Access Compliance Report

Public Rights-of-Way

Intersection ID: 9211	Main Street: E_SUGAR_CREEK_RD	Cross Street: GREENSBORO_ST	Location: E
ADA ID: BC9F4F5CF0DE	Ramp Type: PerpDiag	Initial Pass/Fail: Fail	Overall Compliance: No
		Severity Score: 25

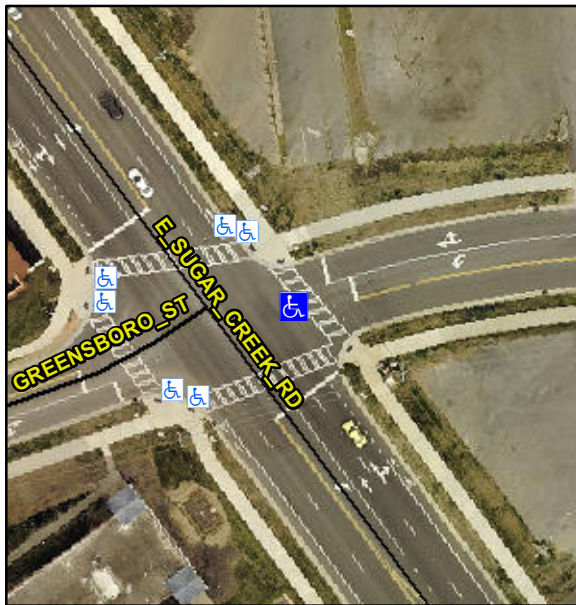
Not Found, R304.5.3

Compliance	Description	Data	Compliance	Description	Data
N/A	Ramp Length (in)	147.0	Yes	Ramp Slope (%)	5.4
Yes	Ramp Width (in)	52.0	No	Ramp XSlope (%)	7.0
N/A	Flare Type LT	N/A	N/A	Flare Type RT	N/A
N/A	Flare Slope LT (%)	N/A	N/A	Flare Slope RT (%)	N/A
N/A	Flare Traversable LT?	N/A	N/A	Flare Traversable RT?	N/A
N/A	Landing Length (in)	N/A	N/A	DWS Provided?	N/A
N/A	Landing Width (in)	N/A	N/A	DWS Contrast?	N/A
N/A	Landing Slope (%)	N/A	N/A	DWS Length (in)	N/A
N/A	Landing X Slope (%)	N/A	N/A	DWS Full Width?	N/A
N/A	Landing Curb? (Y/N)	N/A	N/A	DWS Offset (in)	N/A
N/A	Shared Landing?	N/A			
N/A	Gutter Ponding?	N/A	N/A	Gutter Slope (%)	N/A
N/A	Gutter Lip Ht (in)	N/A	N/A	Gutter X Slope (%)	N/A
N/A	Painted X Walk1?	Yes	N/A	Painted X Walk2?	Yes
	X Walk 1 Direction	To NE		X Walk 2 Direction	To SE
N/A	X Walk 1 Width (in)	112.0	N/A	X Walk 2 Width (in)	108.0
	X Walk 1 Slope (%)	2.7		X Walk 2 Slope (%)	7.2
	X Walk 1 X Slope (%)	6.2		X Walk 2 X Slope (%)	0.2

Remove & Replace Curb Ramp With Two New Directional Ramps or Equivalent.
